**Re: Project, Permit No. M-1980-244;
Technical Revision (TR-124) Preliminary Adequacy Review**

Carlton Tunnel Mapping Adjustment

Figure 1. SLB Overlap Area

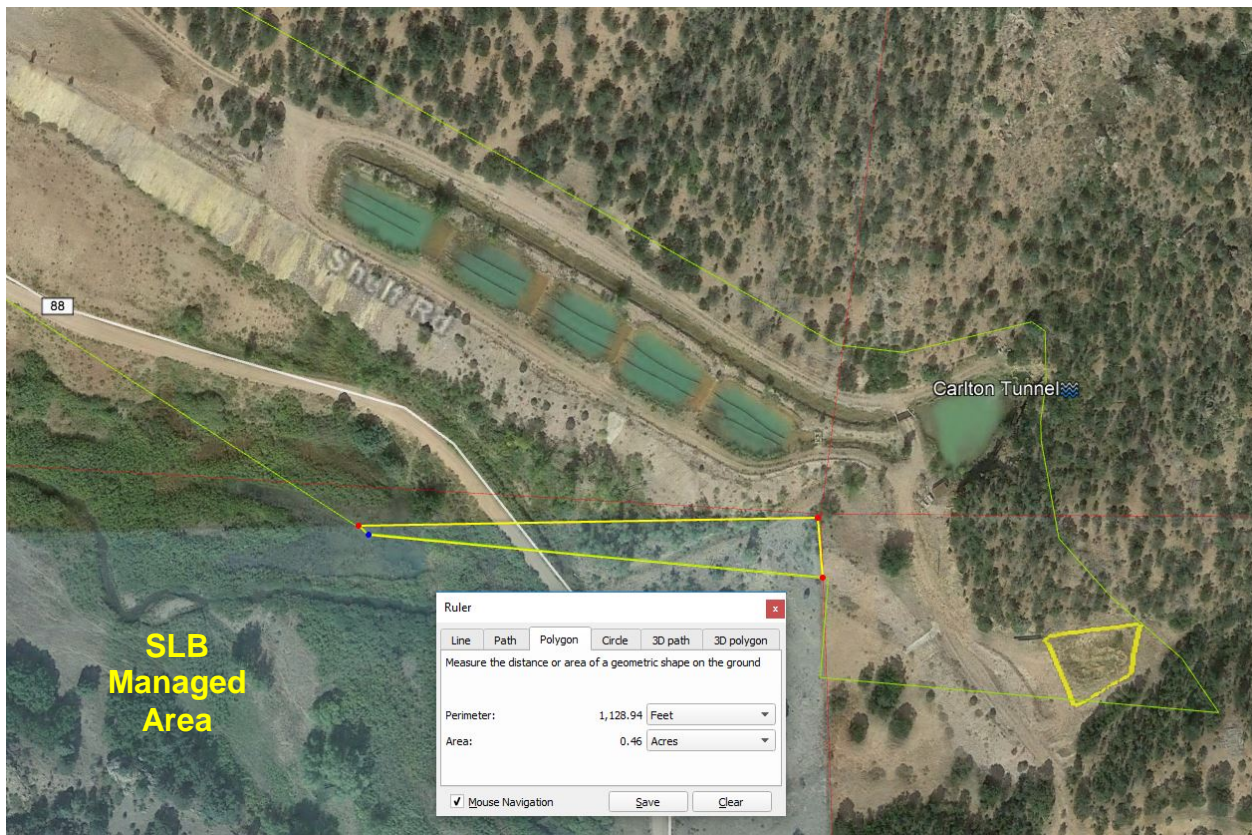
- 1) Legal Right of Entry: There is an area of nearly 0.5 acres on the proposed boundary clarification map that overlaps land managed by the State Land Board (SLB), see Figure 1. The inclusion of this area would require documentation authorizing legal right of entry from the SLB. If this was the original intent, such documentation should already exist. Please either provide legal right of entry or recheck your records to eliminate this overlap from the boundary clarification map.
